### Development Team Review Comments

Re: Steele Street Center Rezoning  
Case No. RCU2025-00018

Examples of approved turnarounds:

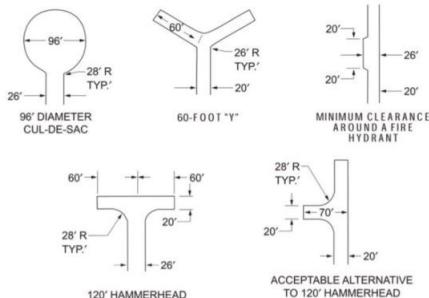
7. Any dead-end fire apparatus access road in excess of 150' shall be provided with an approved turnaround.

8/22/2025 – Does not apply, no dead-ends are shown on the conceptual plan.

The examples are noted. However, the standard that would require approved turnarounds does not apply.

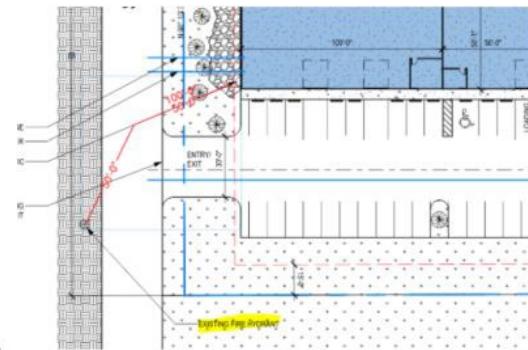
13. The FDC for each building with a fire sprinkler system must be located within 150 feet of a fire hydrant.

8/22/2025 – Appears to be met, proposed plan shows an existing hydrant and the FDC proposed location are within 100 feet:

**Acknowledged.**

# **ARCHITECTURAL SITE PLAN**

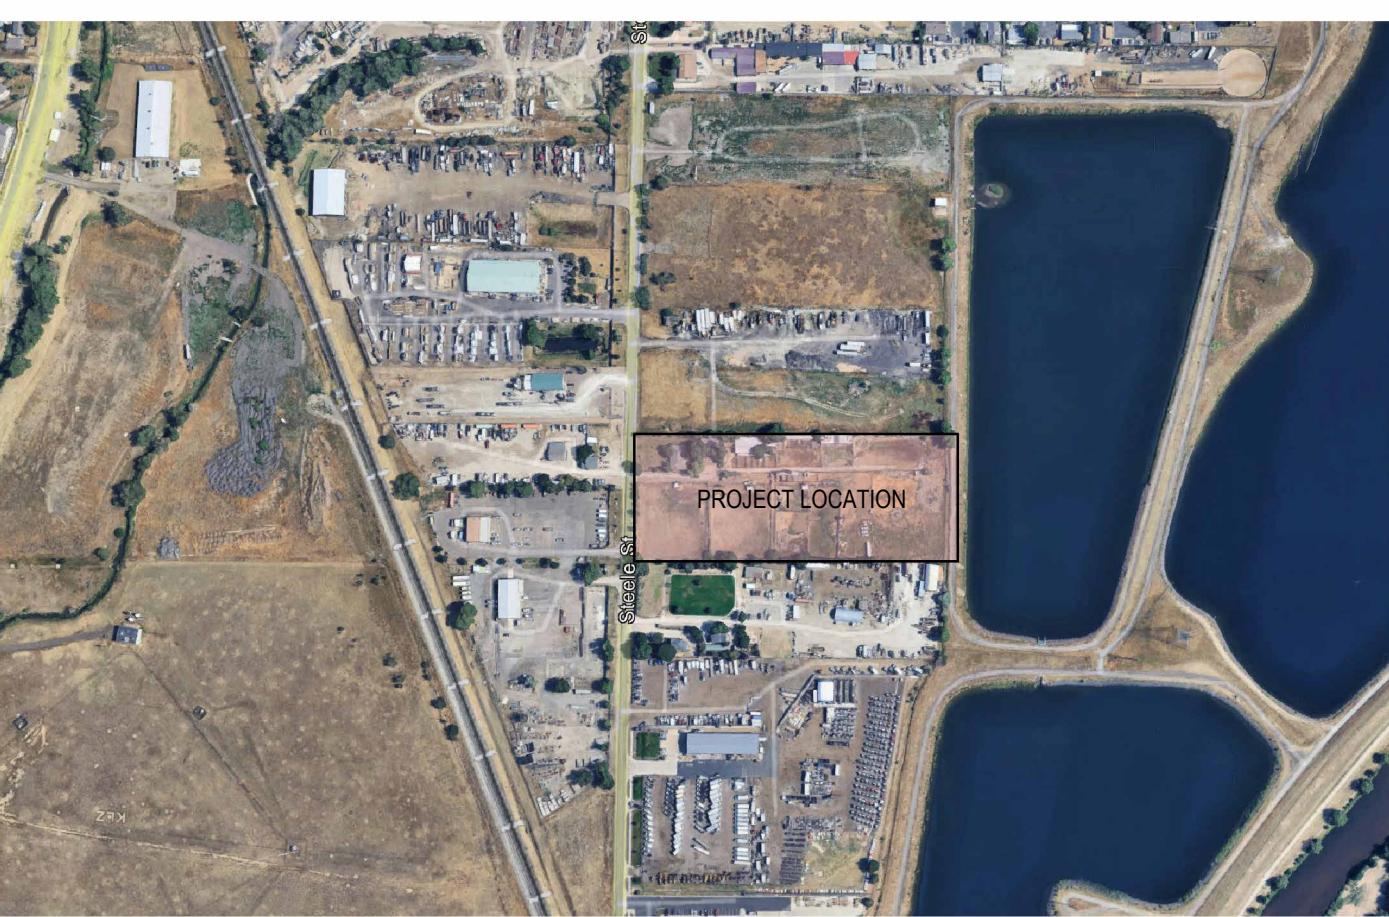
PLN03: Please provide complete lot width. While property appears to meet 100 ft. minimum for the Industrial-1 zone district via GIS, please confirm.

ROW1: There was a CIP project in 2022 and there was ROW exacted from the owner by Warrant Deed recorded at Reception No: 2022000096572. Site plan must cite this exaction.

**The lot width is approximately 327 feet. The dimension is added to site plan sheet A100, which is included with this resubmittal.**

**A corresponding note is added to site plan sheet A100, which is included with this resubmittal.**

City of Thornton SUR comments are addressed on Sheet A100, which is included with this resubmittal.
